SERVICE INFORMATION NO. SI 40NG-033/1

Austro Engine Mandatory Service Bulletin No. MSB-E4-007/6
ATA-Code: 71-00

No. MSB-E4-007/6
SUPERSEDES DOC. No. MSB-E4-007/5

Replacement of Waste Gate Controller

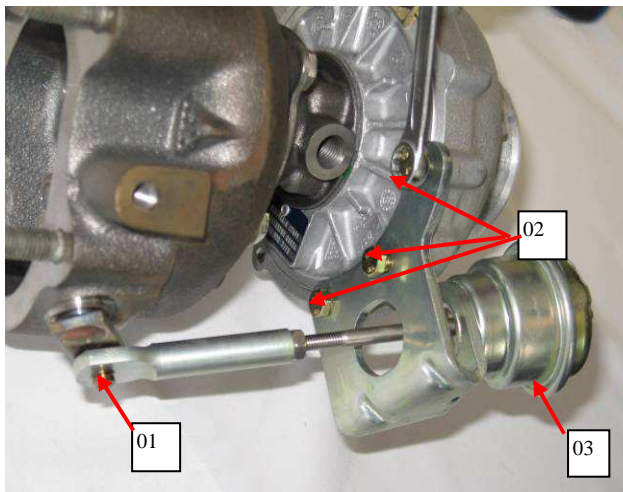
Removal of installed Waste Gate Controller:

1. Disconnect Hose at the top of the Waste Gate Controller
2. Remove three M6 Bolts [02]
3. Remove Circlip [01]
4. Disconnect rod from waste gate lever and remove waste gate controller [03]

Install new Waste Gate Controller according to table section 3.1.

1. For installation refer to the instructions given in the Engine Maintenance Manual E4.08.04, Chapter 81-00-14 and Chapter 81-00-32.
